Subject: Inspection 87-03 - Environmental Qualification of
Electrical Equipment 10CFR50.49
R.E. Ginna Nuclear Power Plant
Docket No. 50-244

VICTOREEN HIGH-RANGE RADIATION MONITOR (PACKAGE #36)

NRC "POTENTIAL ENFORCEMENT CONCERN"

Figure V-1

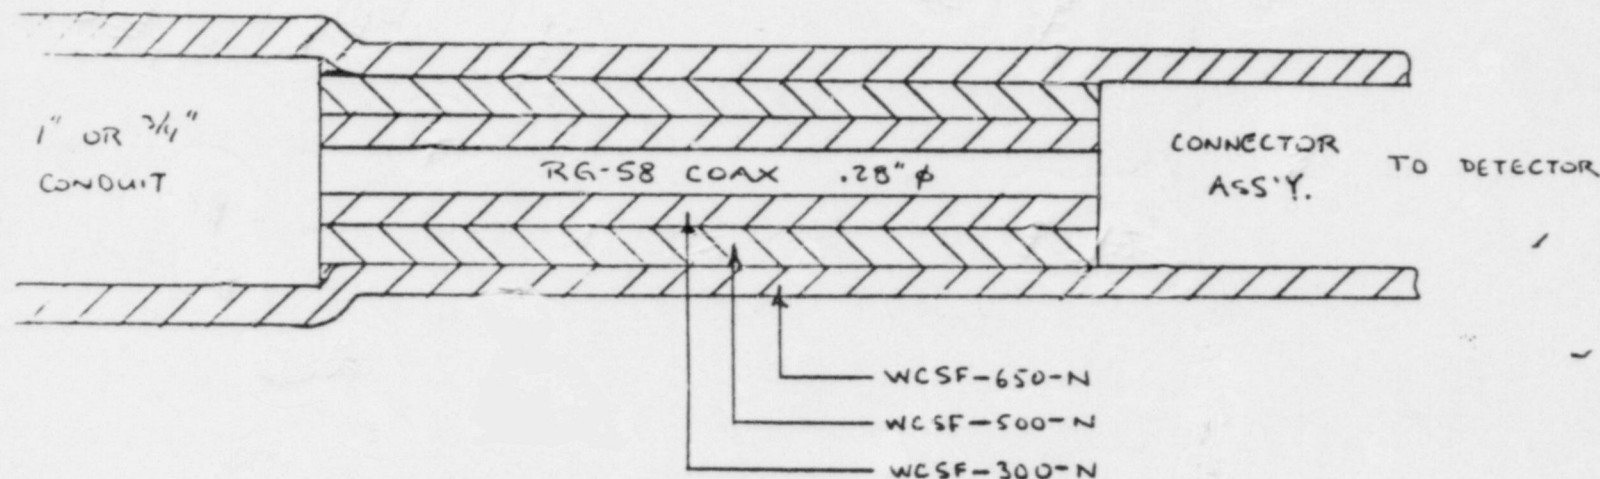
The RG&E method used to seal the connector-detector-cable interface does not adequately address the test failures in the Victoreen Qualification Test Report (950.301).

The RG&E sealing method, using built-up Raychem sleeves over the coaxial cable, with an overall Raychem sleeve over the connector and conduit, is depicted in Attachment 1 to this enclosure, Figure V-1 (from RG&E EEQ Package #36, Reference 3.b.1), and the Attachment 2 photograph. RG&E believes that this sealing method explicitly addresses all leakage path failure mechanisms determined in the Victoreen Qualification Test Report 950.301 (RG&E Reference 3.b.4).

ATTACHMENT 4
FIGURE 1

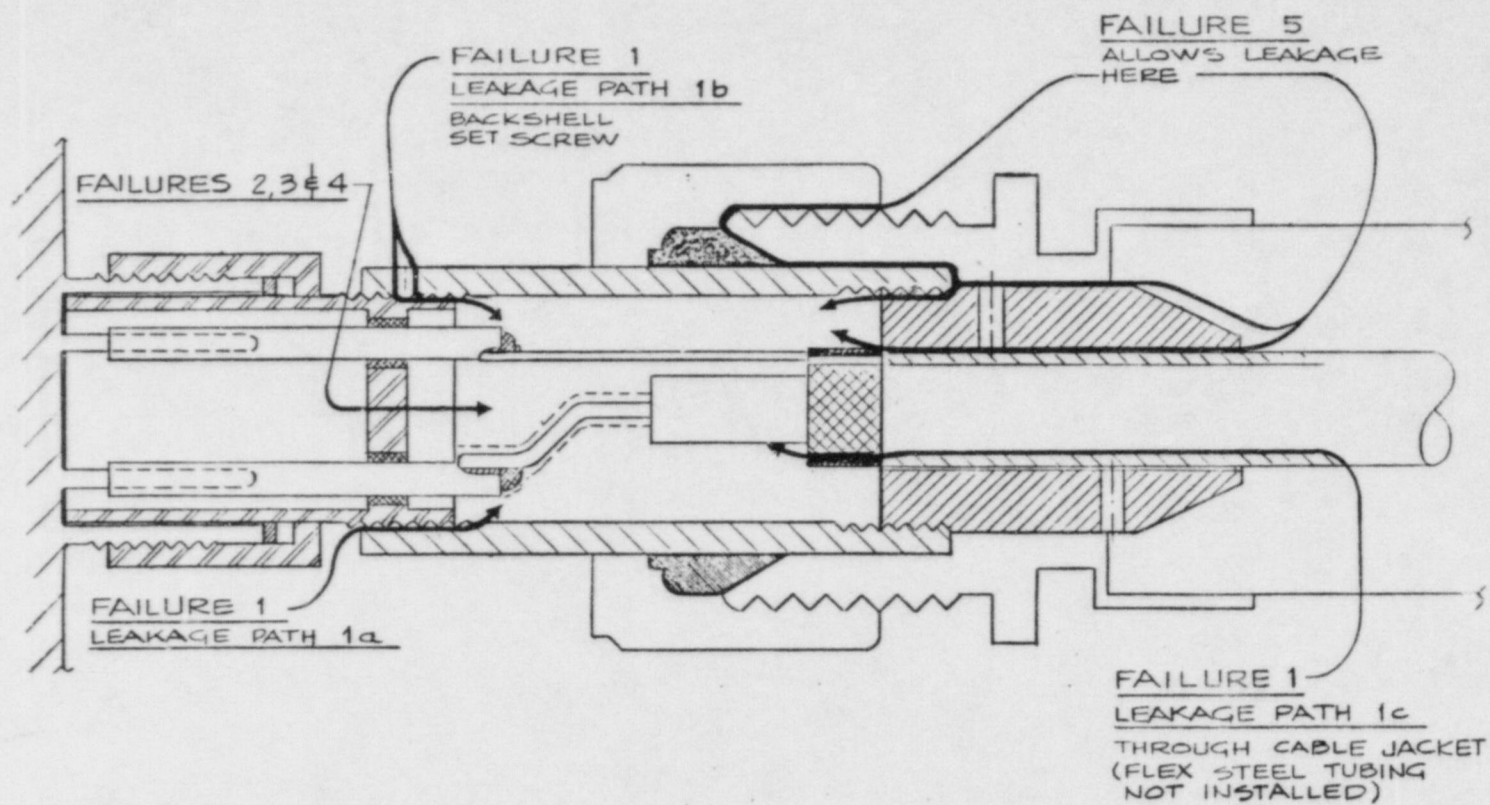
Victoreen Test Report 950.301, Section V, pages 60 and 61 (Attachment 3) lists the failure mechanisms which occurred during the unsuccessful attempts at qualification. Attachment 4 is a set of 3 drawings which show a) a detailed representation of the detector-connector cable assembly (this is an enhanced version of Figure 2, Section VI, page 51 of Victoreen Test Report 950.301), b) a representation of the failure leakage paths described in Attachment 3, and c) a comparative representation of RG&E's installed configuration. There were no failures attributed to the connection at the base of the detector.

The analysis of these failure mechanisms, and the graphical depictions of RG&E's seal method vs. the failure leakage paths described in Attachment 4 provides assurance that the Victoreen high range radiation monitor, as installed at Ginna Station, will perform its required safety function. All the leakage failure paths identified in the qualification test report have been addressed and corrected.

ENG. DEPT.	STATION: GINNA	DATE: 3-3-87	PAGE 1 OF 3
JOB: 10 CFR 50.49 COMPLIANCE	MADE BY: DPS		CK:

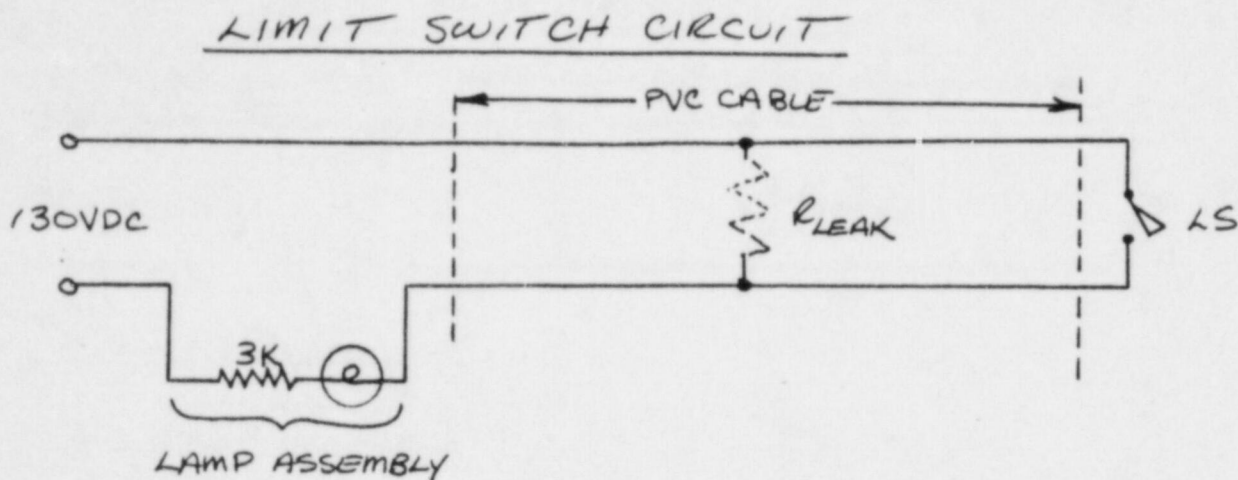
Similarity between tested and installed cables was not definitively established.

For the PORV limit switch circuit there is a resistor in series with the indicating light which drops the circuit voltage from 130 volts to 30 volts across the indicating light. The indicating light for the valve's actual position (open (red) or closed (green)) would be on and bright. If leakage occurred, this light would remain bright, since the insulation resistance would be shunted by the closed limit switch contact. The only possible confusion could arise on the limit switch circuit which indicates the position the valve is not in. For a "false" indication to occur, the cable leakage resistance would have to shunt an open limit switch. As noted in the calculations, (Attachment 3), using the results of Test Report 45307-1, the "false" indication would only be 1/7 the illumination of the "true" indication. Using the results of the new Acton test (not in the EEQ Package #44 at the time of the inspection), the "false" indication would be 1/10 of the illumination of the "true" indication. It is not considered that there would be any operator confusion at these levels.

$\therefore E = IR$
 $(130-15) = (0.0167)(3000 + R_{LEAK})$
 $R_{LEAK} = 3886 \text{ OHMS (FOR WHOLE CABLE, CONDUCTOR TO CONDUCTOR)}$
